**SUNDRY NOTICES AND REPORTS ON WELLS**  
**Do not use this form for proposals to drill or to re-enter an**  
**abandoned well. Use Form 3160-3 (APD) for such proposals.**

8. Well Name and No.  
Querecho 28 NC Federal #1H

Mewbourne Oil Company would like to make changes to the original APD as follows.

**PECOS DISTRICT  
CONDITIONS OF APPROVAL**

# 11" 3M BOPE & Closed Loop Equipment Schematic

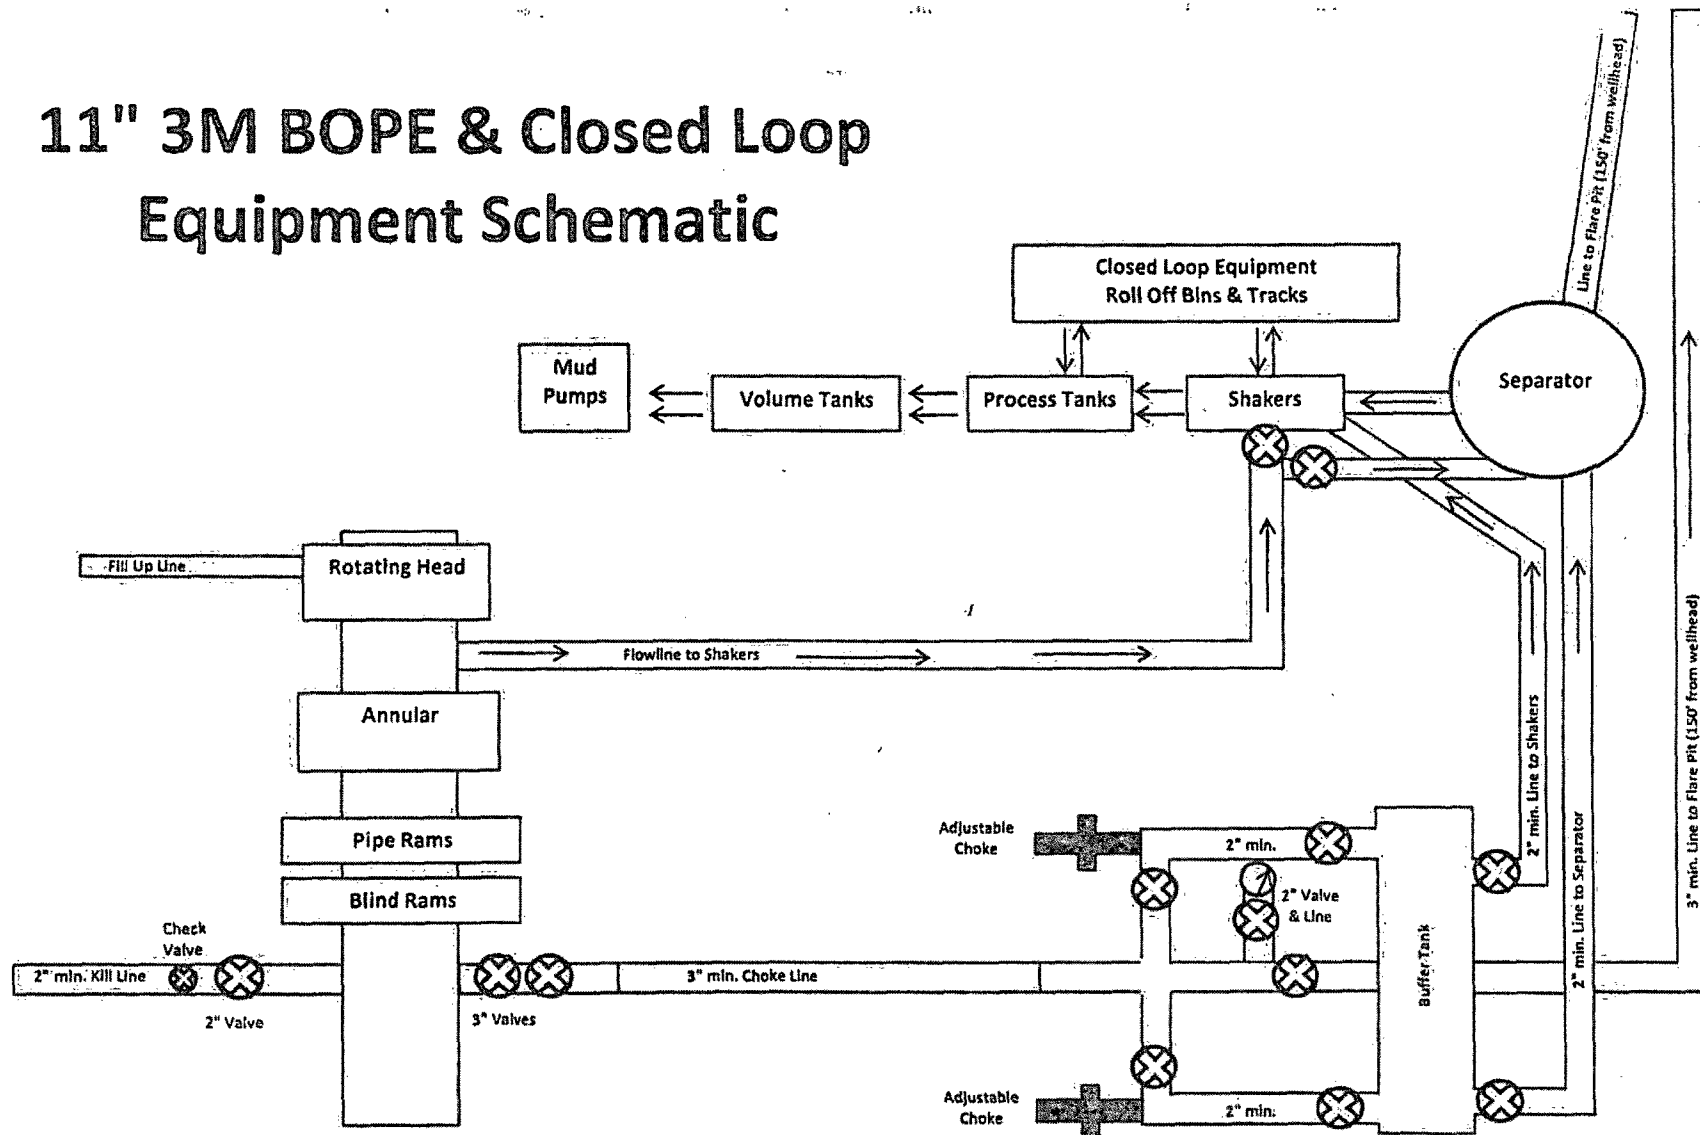
Request to change minimum working pressure of BOPE & related equipment required for drilling below 9 5/8" & 7" csg shoe from 5000# to 3000#.

3. Minimum working pressure of the blowout preventer (BOP) and related equipment (BOPE) required for drilling below the **9-5/8** inch intermediate casing shoe shall be **3000 (3M)** psi.
